Work Order ID 104669

Item Name: Fwd Crosstube - High

DRAWING NO. D212-664-141	REV. D SHEET 1 OF 4
TITLE XTUBE ASSY (205/212/412 HI FWD)	SCALE NTS

DRAWING NO. D212-664-141	TITLE XTUBE ASSY (205/212/412 HI FWD)	REV. D	DART AEROSPACE LTD ENGINEERING ORDER		D.E.O. NO. D212-664-141-D-1	SHEET NO. SHEET 1 OF 2	SCALE NTS
DRAWN	CHECKED	MP	MFG. APPR.	RE	APPROVED	NA	DE APPR.
DATE 11.04.07	DATE 11.07.11		DATE 11.04.12		DATE 11/04/12		DATE 11.04.12

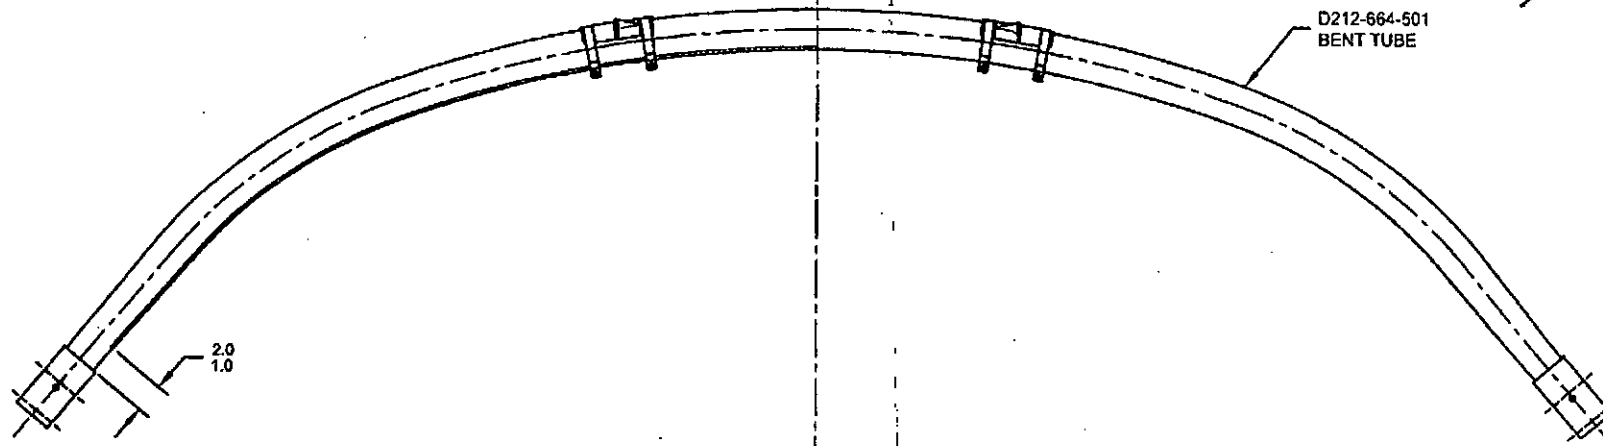
ADD AN INSPECTION WINDOW TO UNDERSIDE OF CROSSTUBE.

NOTES 2 OF SHEET 1 IS AMENDED AS FOLLOWS:

- 2) FINISH: CHEMICAL CONVERSION COAT PER DART QSI 005 4.1
PRIME INSIDE AND OUTSIDE PER DART QSI 005 4.2
MASK UNDERSIDE OF CROSSTUBE AS SHOWN (HATCHED AREA) AND
PAINT OUTSIDE PER DART QSI 005 4.2
REMOVE MASKING AND APPLY CLEAR COAT

MASK AREA PRIOR TO PAINTING,
REMOVE MASKING AFTER PAINT
AND APPLY CLEAR COAT
